Exhibit 'I'

Bureau of Alcohol, Tobacco,
Firearms and Explosives

This is in reference to your correspondence to the Bureau of Alcohol, Tobacco, Firearms and Explosives (ATF), Firearms Technology Branch (FTB), which accompanied your prototype sample of an AR-10 type receiver blank your company intends to manufacture and market. Specifically, you requested an examination and classification of the submitted sample pursuant to the amended Gun Control Act of 1968 (GCA) and asked if it would be regulated as a "firearm" under the GCA.

Submitted prototype sample

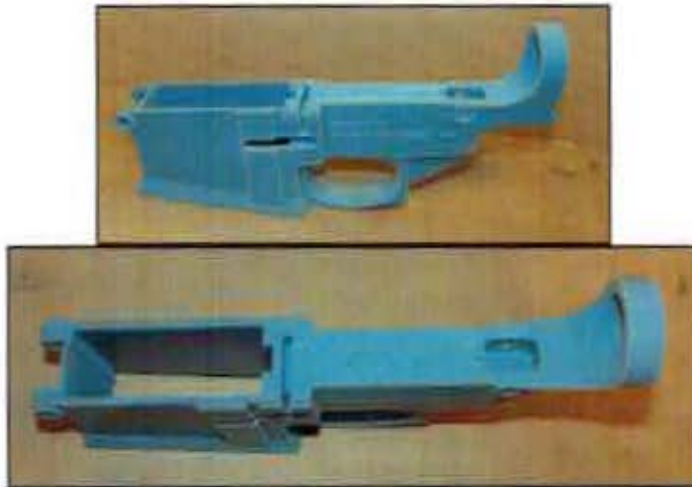
Our examination of the submitted item confirmed that the receiver blank has been partially machined, including a takedown pin hole and clearance for the takedown-pin lug. Our examination confirmed that the takedown-pin lug clearance area is less than 1.6 inches, measured from immediately forward of the front of the buffer-retainer hole (see photos below). The sample is completely solid and un-machined in the fire-control recess area and, accordingly, is not a "firearm" as defined in the GCA.
